Safety Bulletin

No: SB037

Hitch pin c/w hairpin replacement with Hitch pin c/w safety pin and lanyard

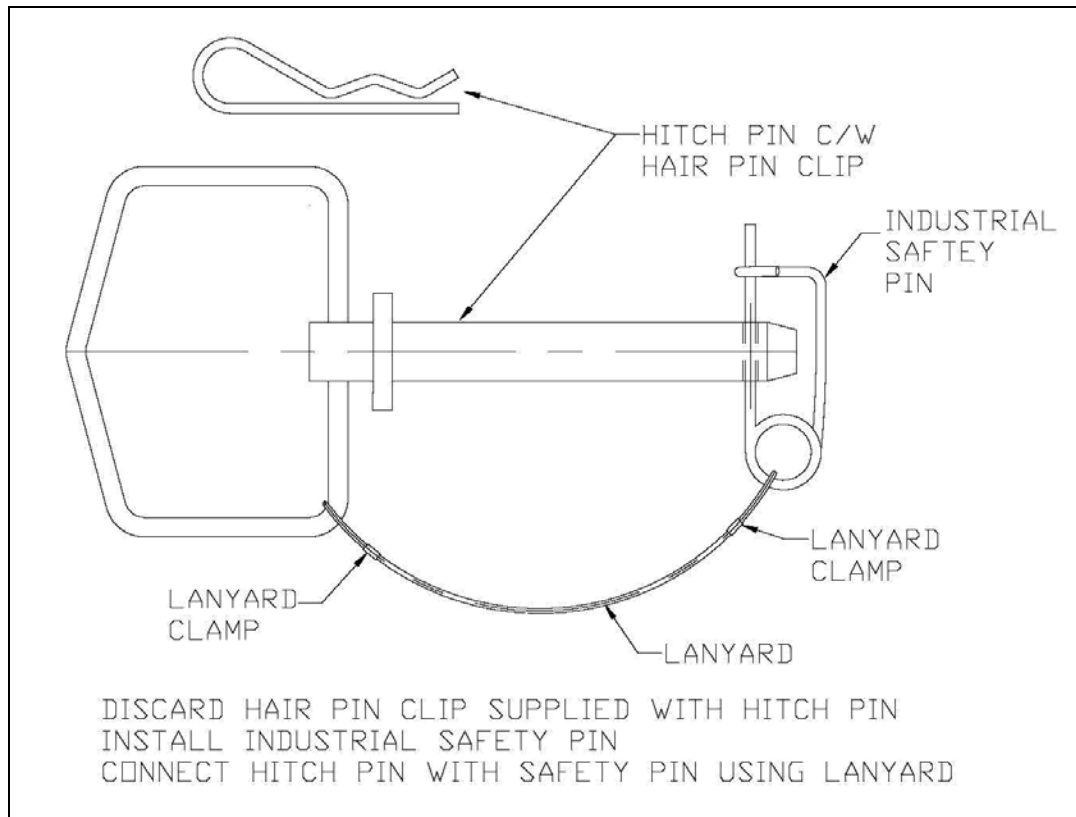
Hitch pin c/w hair pin clip were used on some TESCO top drives and rig up kits. The hair pin clip may fall off when hit by another object, which may result in the hitch pin itself falling off, creating danger for personnel on the rig floor.

If hitch pin c/w hair pin clip was installed in an overhead equipment application, it is highly recommended to replace hair pin clip with industrial safety pin, then connect hitch pin with safety pin using lanyard.

1410060 Hitch pin c/w safety pin & lanyard
